**Planning Department
Transportation Development Services**

**Re: Jefferson Middle School, Phase I
712 Girard NE
Traffic Circulation Layout**
Engineer's/Architect's Stamp dated 10-13-15 (J16-D007)

DRAINAGE AND TRANSPORTATION INFORMATION SHEET (REV 09/2015)

Project Title: JEFFERSON MIDDLE SCHOOL PHASE 1 MUSIC CLASSROOM ADDITION Building Permit #: _____ City Drainage #: J16-D007
DRB#: _____ EPC#: _____ Work Order#: _____
Legal Description: 712 GIRARD BLVD NE
City Address: _____
Engineering Firm: _____ Contact: _____
Address: _____
Phone#: _____ Fax#: _____ E-mail: _____
Owner: _____ Contact: _____
Address: _____
Phone#: _____ Fax#: _____ E-mail: _____
Architect: DEKKER/PERICH/SABATINI Contact: SUSAN SPENCER
Address: 7101 JEFFERSON AVE NE SUITE 100
Phone#: 505-761-9100 Fax#: _____ E-mail: Susans@pdsdesign.org
Other Contact: _____ Contact: _____
Address: _____
Phone#: _____ Fax#: _____ E-mail: _____

NORTH
1" = 20'-0"
0 10' 20' 40'
ARCHITECTURAL SITE PLAN

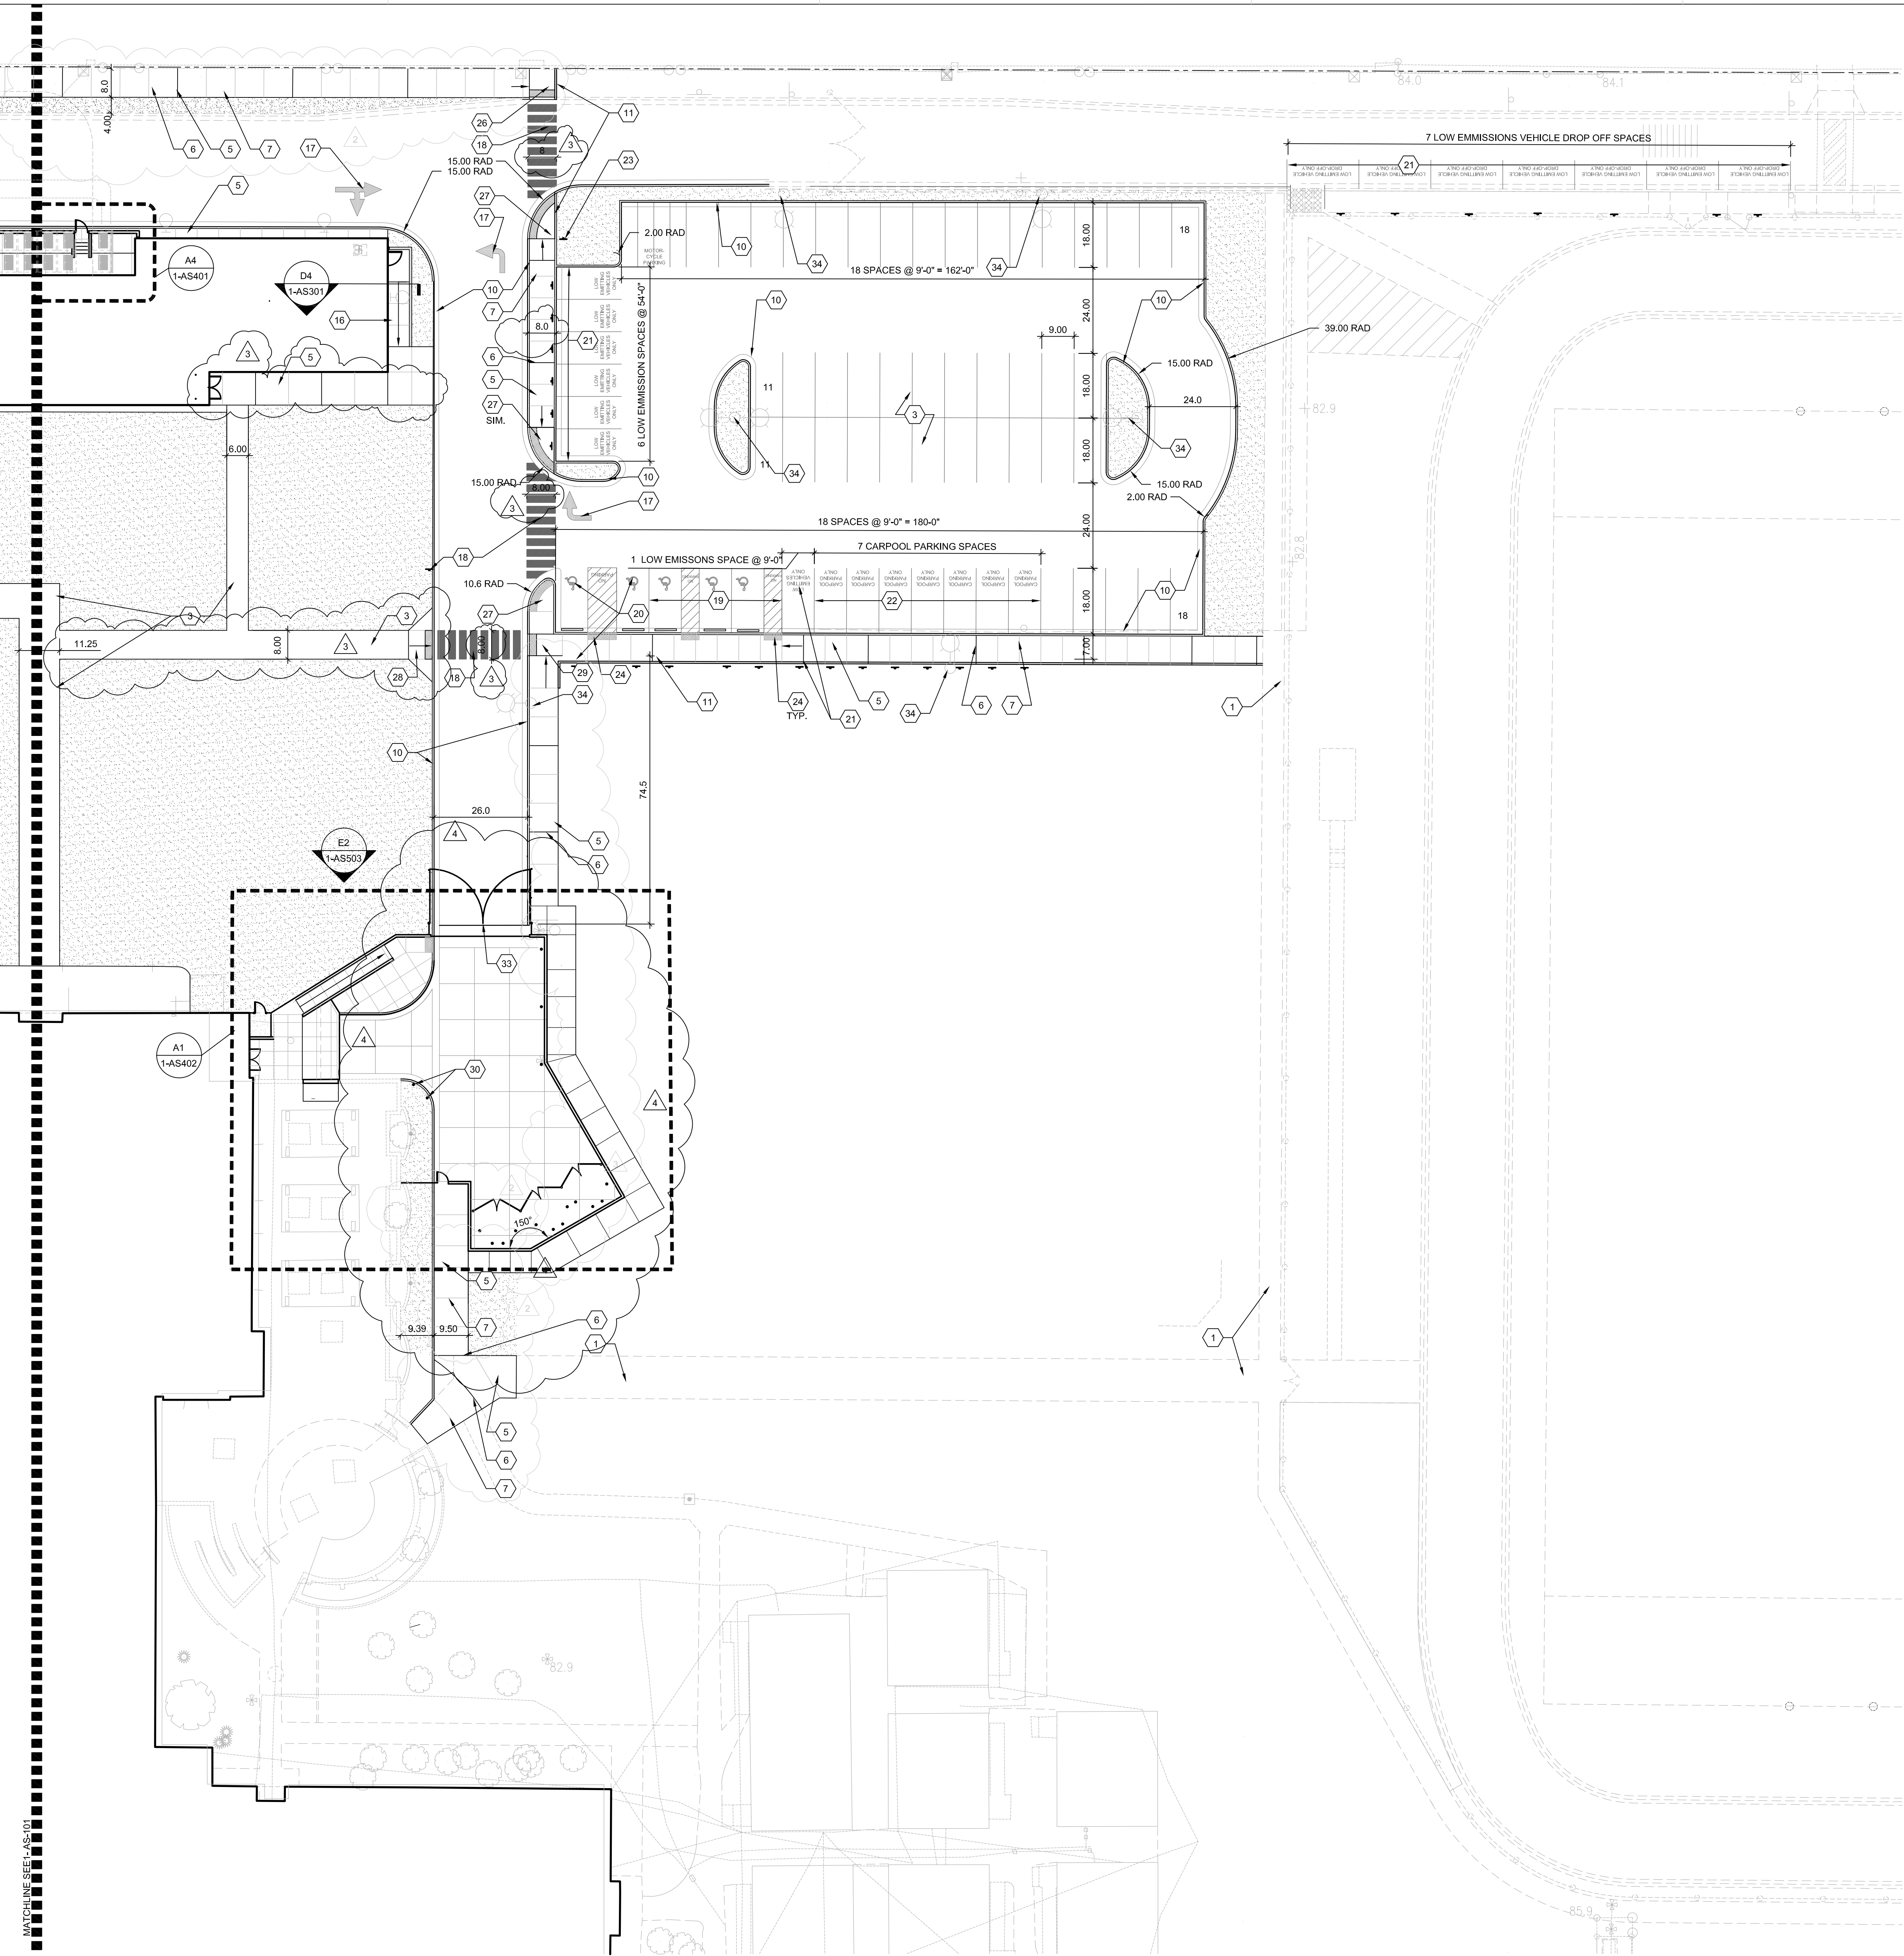
ALL WHEELCHAIR RAMPS LOCATED
WITHIN THE PUBLIC RIGHT OF WAY
MUST HAVE TRUNCATED DOMES.
